Architect's Supplemental Instructions

Wilma P. Mankiller Health Center
Expansion
Stilwell, OK

ASI Number: Bid Package 02 ASI 006

Construction Documents – ASI 06 – Wilma P. Mankiller Health Center Expansion

SHEET NUMBER: **A1.12**

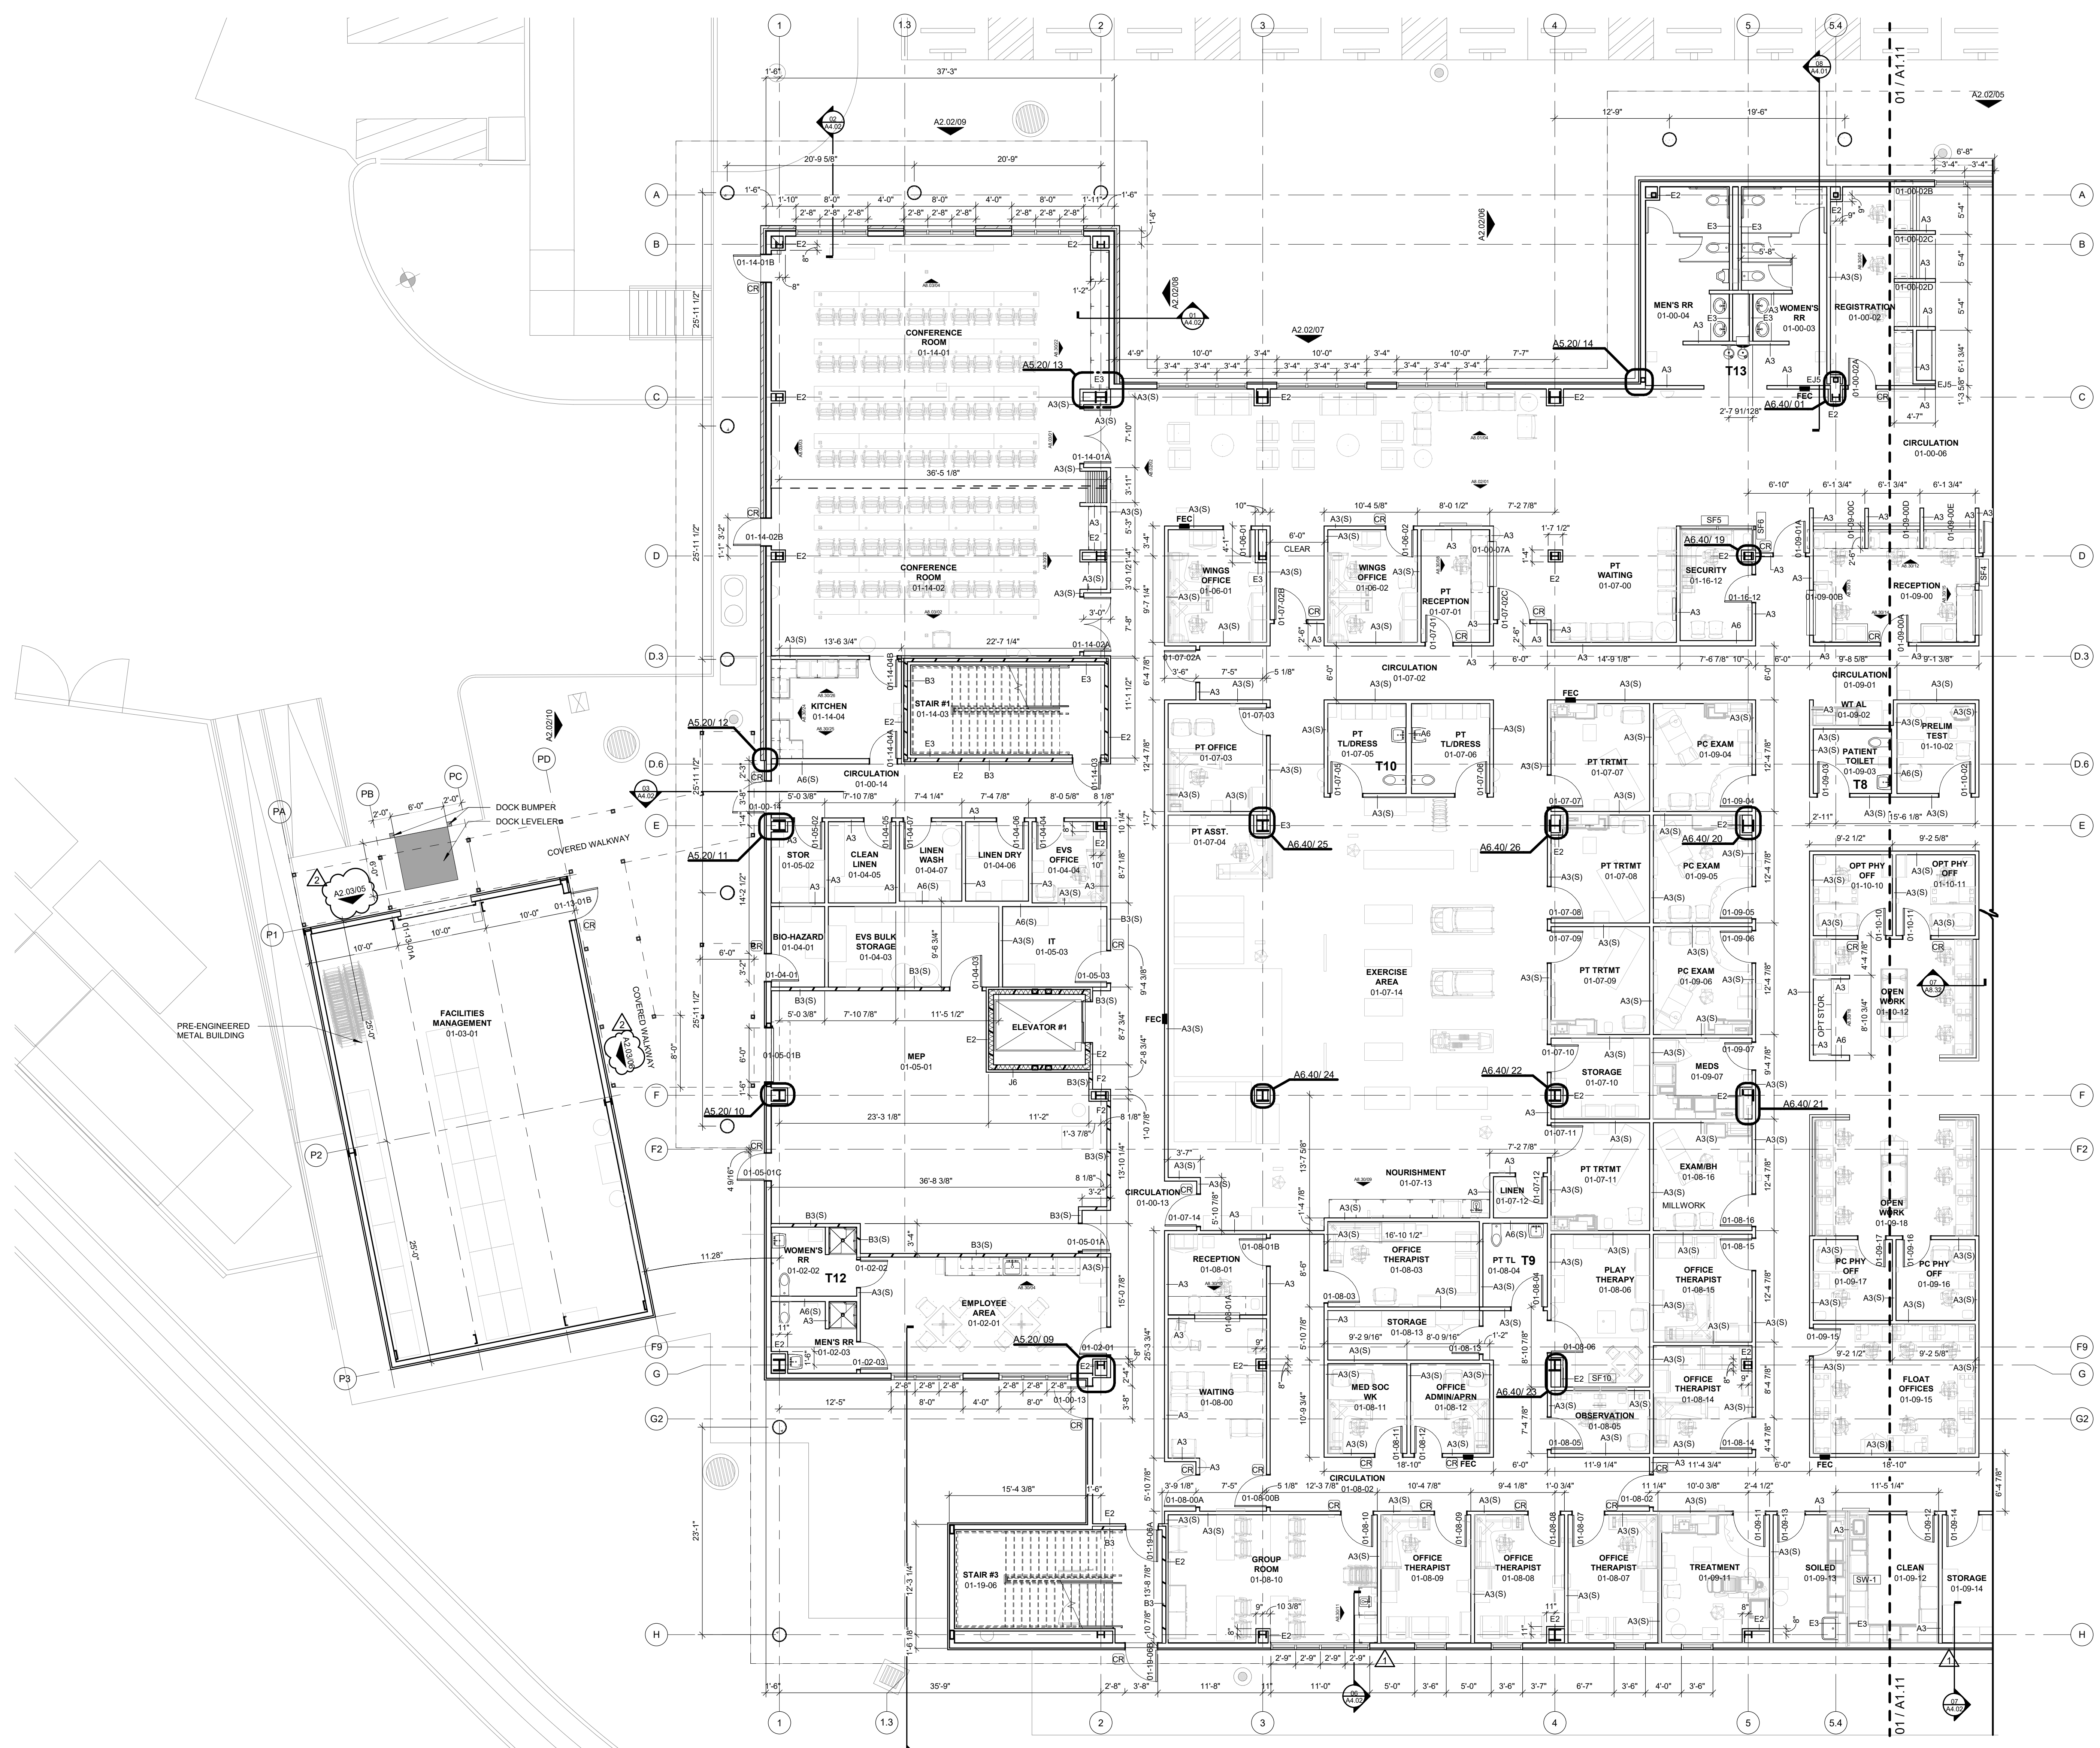
A1.12

1. Elevation Tags added

SHEET NUMBER:
A1.30

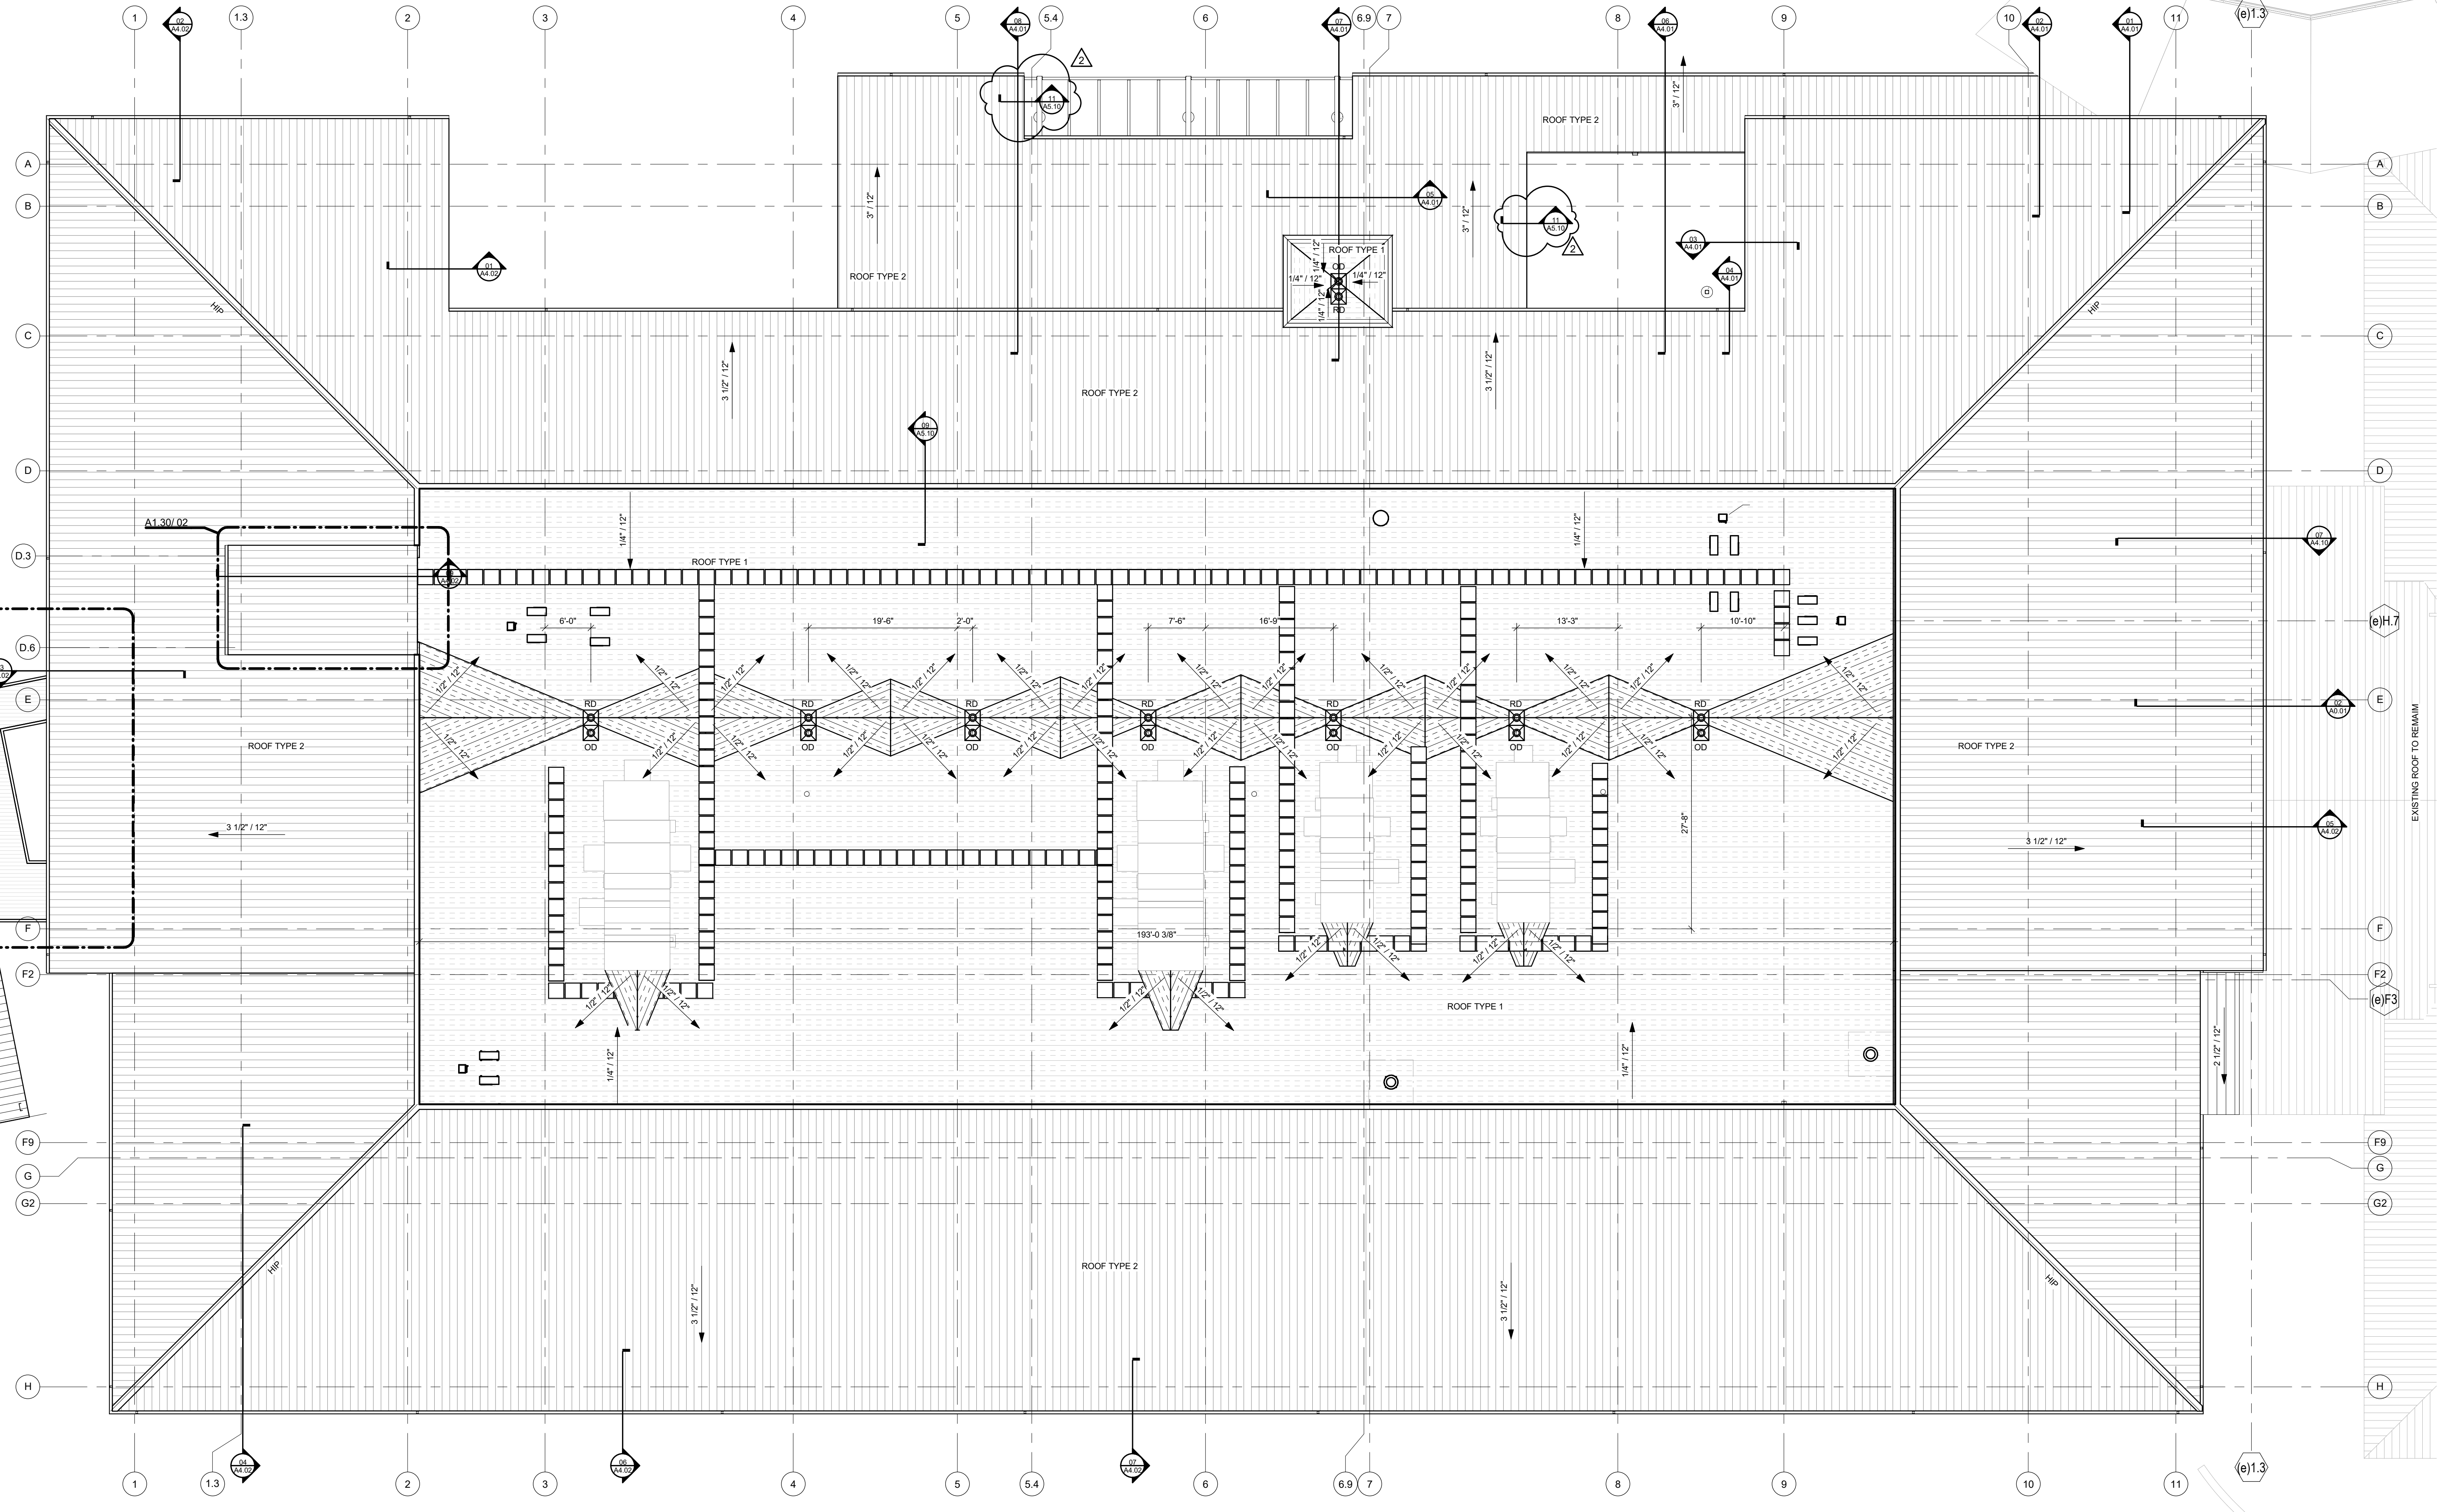
A1.30

1. Section Tags added
